SAFETY EVALUATION BY THE OFFICE OF NUCLEAR REACTOR REGULATION

SUPPORTING AMENDMENT NO. 19 TO PROVISIONAL OPERATING LICENSE NO. DPR-18

R. E. GINNA NUCLEAR POWER PLANT

SAFETY EVALUATION BY THE OFFICE OF NUCLEAR REACTOR REGULATION  
SUPPORTING AMENDMENT NO. 35 TO FACILITY OPERATING LICENSE NO. DPR-42  
AMENDMENT NO. 29 TO FACILITY OPERATING LICENSE NO. DPR-60  
NORTHERN STATES POWER COMPANY  
PRAIRIE ISLAND NUCLEAR GENERATING PLANT UNIT NOS. 1 and 2  
DOCKET NOS. 50-282 AND 50-306

OPERATING ENVELOPE FOR  $F_Q = 2.21$

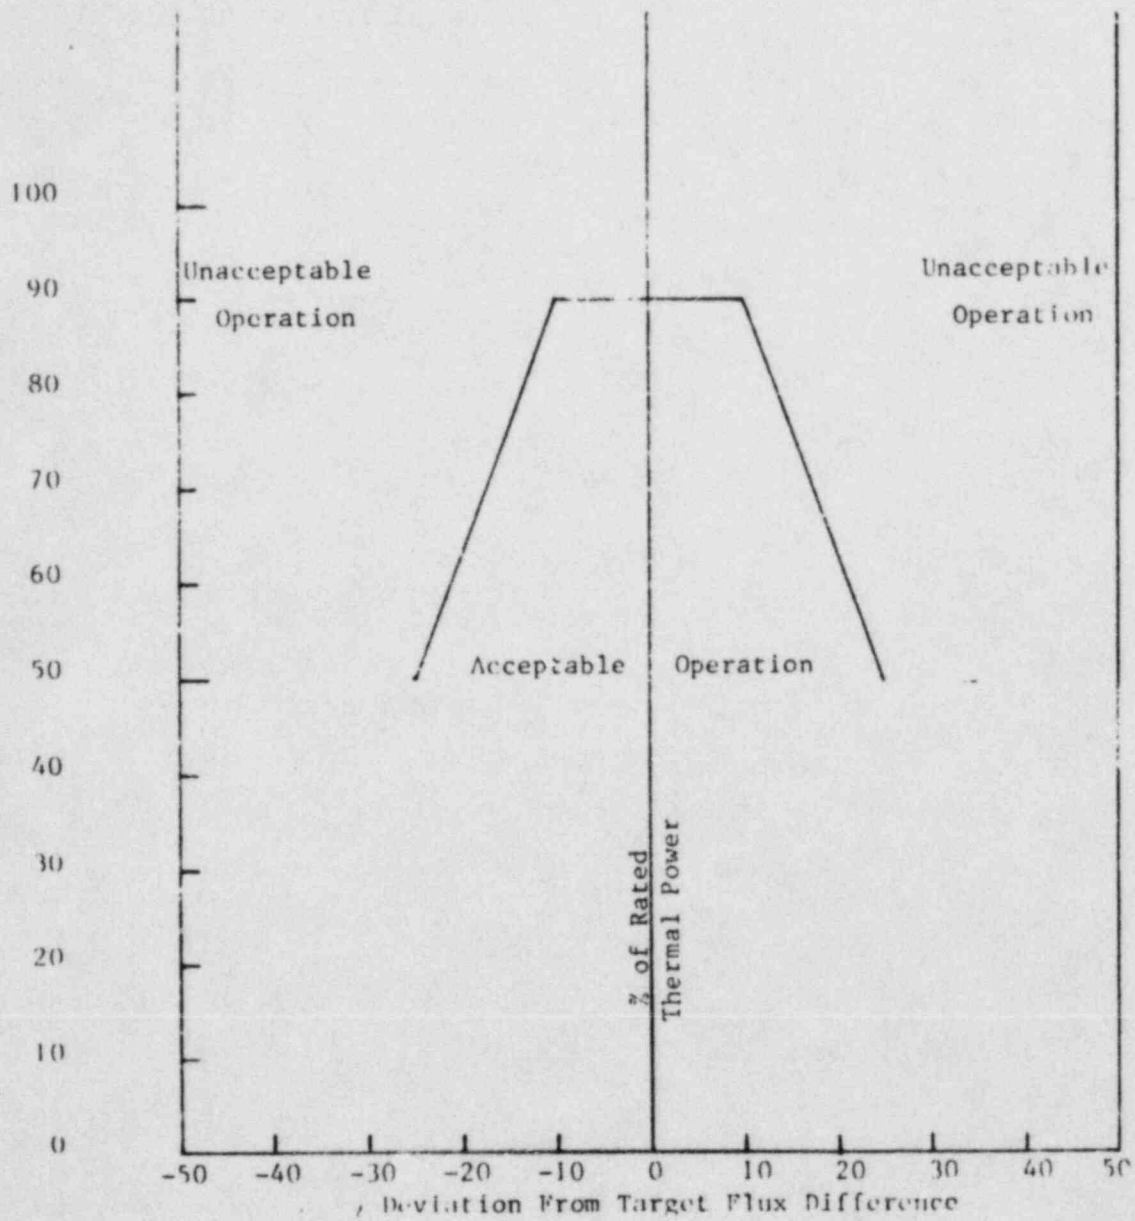
The ENC LOCA analysis for the Prairie Island Units (Reference 6) assumes as an initial condition that the core peaking factor,  $F_{Q^T}$ , is 2.21. Provision is required to ensure that this  $F_{Q^T}$  is not exceeded in normal operation of the power plant in order for the conclusions of the LOCA analysis to remain valid. The licensee has proposed to accomplish this through use of ENC Power Distribution Control-Phase 2 (PDC-2) procedures for reload cores (Reference 10).

As described above, the licensee has agreed (Reference 1) to provide extra surveillance and uncertainty allowances to permit application of PDC-2 to the Prairie Island reactors. He has also provided a suitable definition of equilibrium and other measures necessary to implement PDC-2 in proposed Technical Specification changes (Reference 1). We, therefore, find the proposed Technical Specification changes acceptable to ensure PDC-2 procedures will maintain the  $F_{Q^T}$  below 2.21 in normal operation of the Prairie Island reactors.

Figure TS.3.10-6 DEVIATION FROM TARGET FLUX DIFFERENCE AS A FUNCTION OF THERMAL POWER

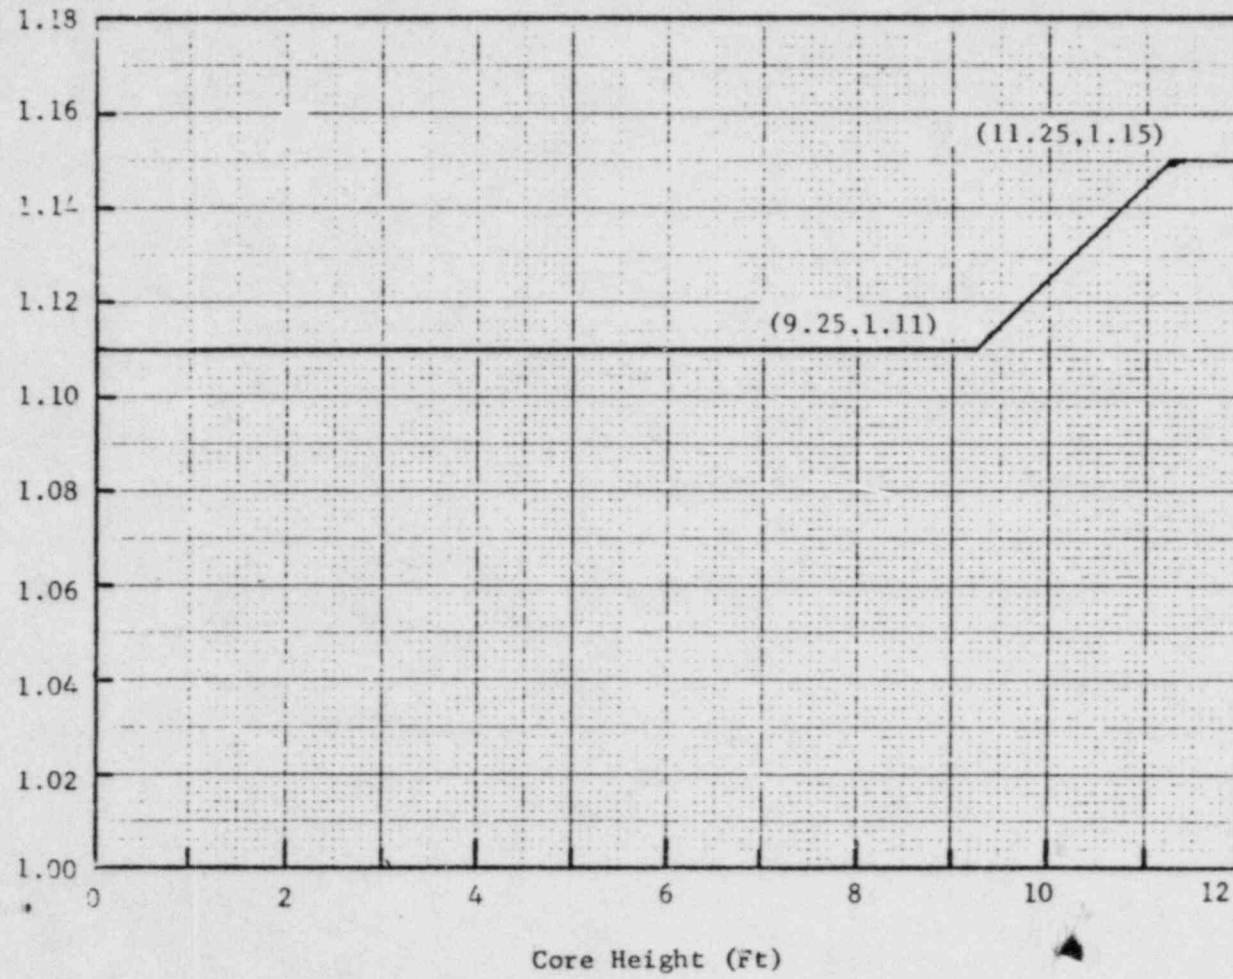
- (1) Change of the limit curve for target flux difference (Fig. TS 3.10-6)
- (2) Addition of a curve defining the transient allowance factor,  $V(Z)$ , used in the Power Distribution Control, Phase 2 procedure (Fig. TS 3.10-8)
- (3) Removal of the definition of the Interim Fuel Limits related to the power distributions to be used in the LOCA analyses and to the fuel residence time in Unit 1, Cycle 1. Deletion of this definition is warranted because the 1971 Policy Statement and 1972 Technical Report have been superseded by the 10 CFR 50 Appendix K criteria and the power distribution limits in Section 3.10 of the Technical Specifications.

6. At a power level no greater than 90 percent of rated power,
    - a. The indicated axial flux difference may deviate from its  $\pm 5\%$  target band for a maximum of one\* hour (cumulative) in any 24-hour period provided that the difference between the indicated axial flux difference and the target flux difference does not exceed an envelope bounded by -10 percent and +10 percent at 90% power and increasing linearly to -25 percent and +25 percent at 50 percent power as shown in Figure TS.3.10-6.
